**A83 TARBET – CAMPBELTOWN TRUNK ROAD**

**STRONE POINT REALIGNMENT**

**ROAD SAFETY AUDIT RESPONSE REPORT**

**STAGE: 3**

Problem Location Plan (extracted from RSA Report)

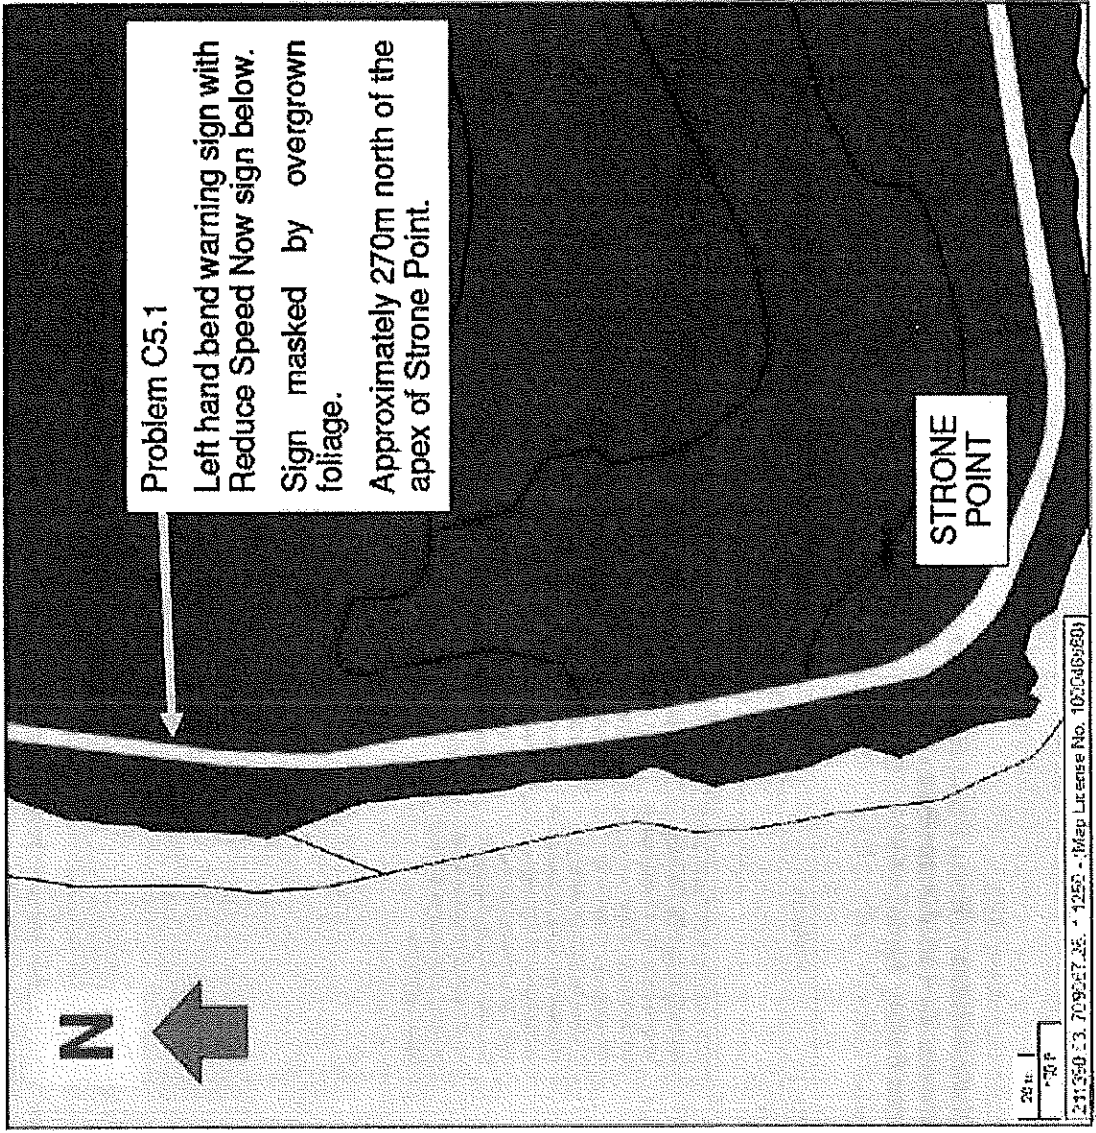
Item	Problem	RSA Recommendation	Accept Problem / Recommendations	Accept Problem but Suggest Alternative Recommendation giving Reasoning	Disagree with Problem and Recommendation and Give Reasoning for Rejecting Problem / Recommendations
C5.1	<p>The existing Left-hand bend warning sign with Reduce Speed Now sign fixed below, on nearside of the carriageway is partially hidden by overgrown vegetation. This reduces the conspicuity of the sign making it easily missed on the approach to the bend which could result in later braking and loss of control type accidents.</p>	<p>Trim back the existing foliage and branches to provide a clear visibility of the signs for a minimum distance of 90m as detailed in the Traffic Signs Manual Chapter 4 Appendix A. The cutting back should be sufficient that future growth does not infringe on the sign visibility envelope.</p>	<p>Problem and recommendations accepted.</p> <p>The area of overgrown vegetation noted was outwith the Contract site boundary and therefore could not be addressed within the traffic management set up in place.</p> <p>Vegetation clearance will therefore be undertaken as part of BEAR Scotland's routine landscaping maintenance.</p> <p>It should be noted that an additional bend warning sign is located on the opposite verge as well as the presence of a Bend Ahead vehicle activated sign. The presence of these signs reduces the overall risk to road users and acts as mitigation until routine maintenance occurs through this section.</p>

Photograph of PROBLEM C5.1  
REDUCE SPEED NOW sign obscured by overgrown foliage.

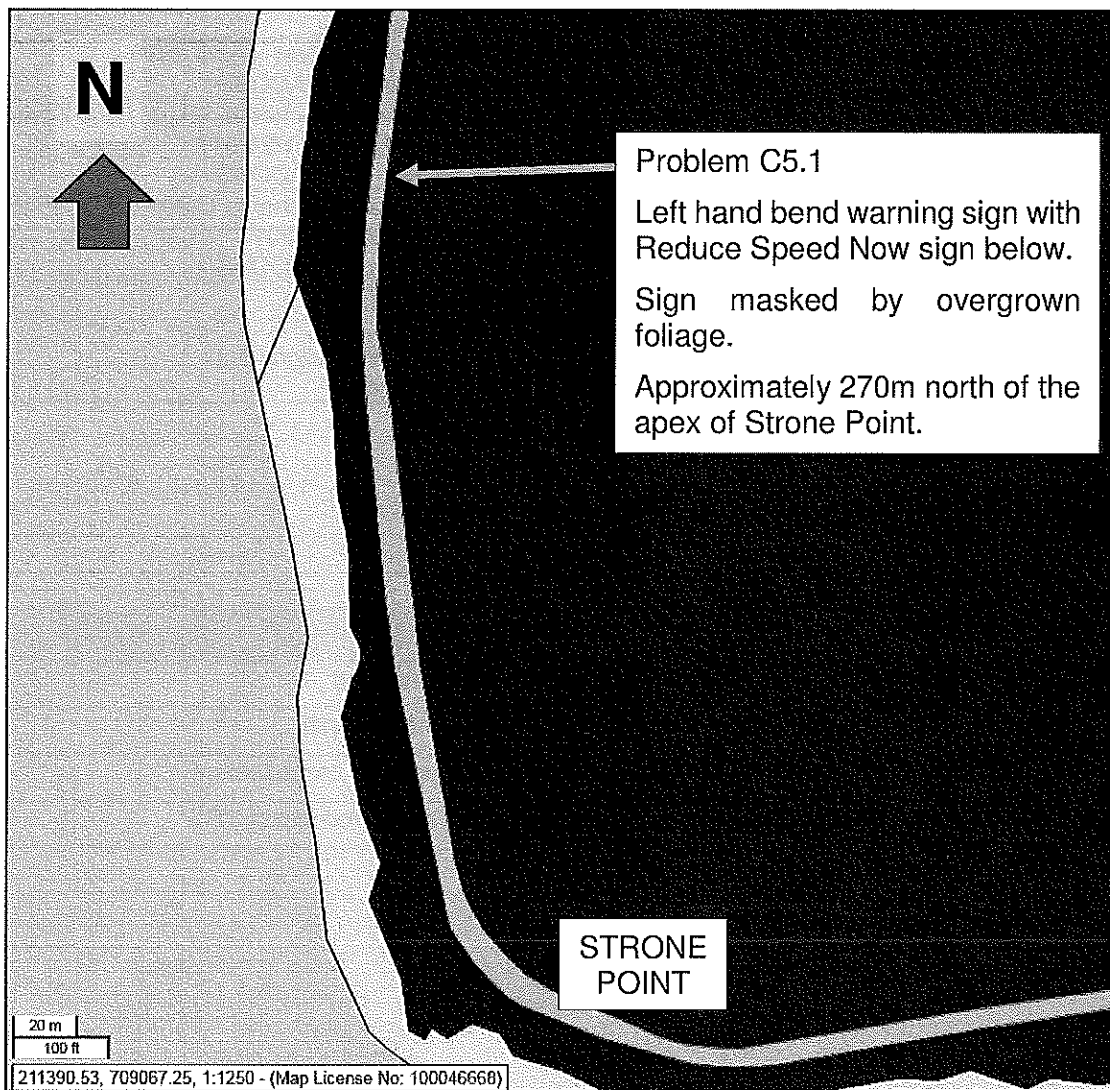
SUMMARY: The existing Left-hand bend warning sign with Reduce Speed Now sign fixed below, on the nearside of the carriageway is partially hidden by overgrown vegetation. This reduces the conspicuity of the sign making it easily missed on the approach to the bend which could result in late braking and loss of control type accidents.

RECOMMENDATION: Trim back the existing foliage and branches to provide a clear visibility of the signs for a minimum distance of 90m as detailed in The Traffic Signs Manual Chapter 4 Appendix A. The cutting back should be sufficient that future growth dose not infringe on the sign visibility envelope.
